Rice Street

Capitol Area Reconstruction

Phase 2 of engagement: Concept evaluation

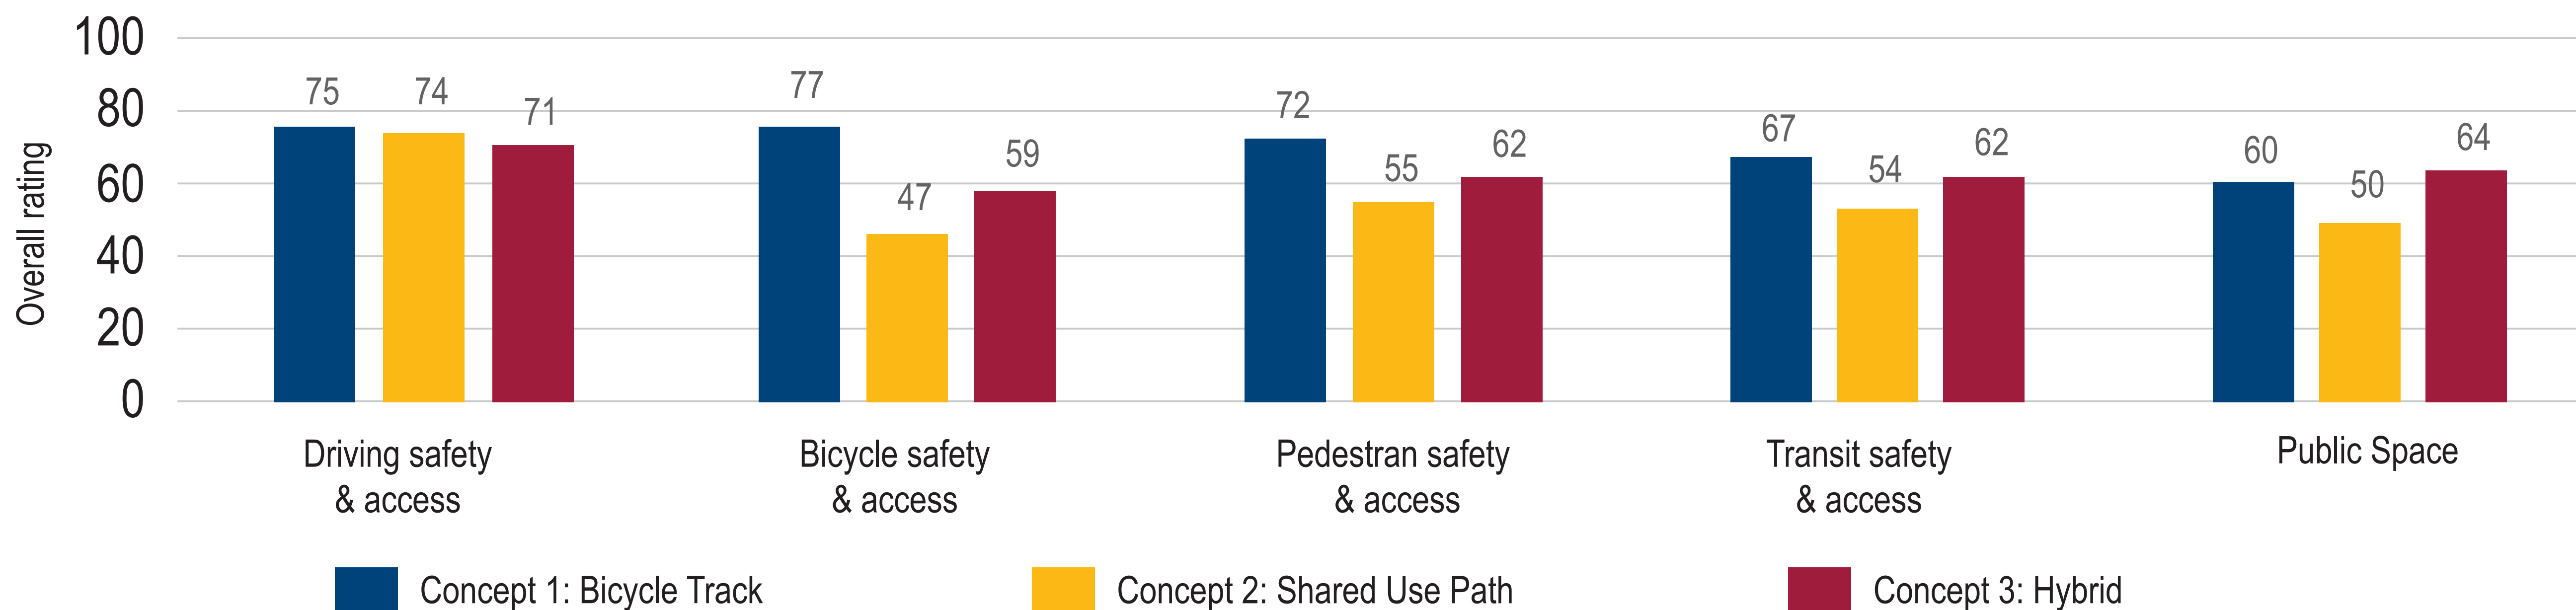
Concept 1 received the highest overall scores, especially for bicyclist safety and access.

Concept 2 ranked lowest overall, primarily due to concerns about bicycle-pedestrian conflicts.

Concept 3 performed well overall, especially in the public space category. It will be important to show how to navigate the transition between the two types of paths.

Given the space constraints north of University Avenue, the project team recommends moving forward **with Concept 3**. The narrower shared-use path north of University Avenue will allow more space for **public space amenities and greenspace**, which were highly prioritized by community members throughout engagement. See the recommended design board for more details.
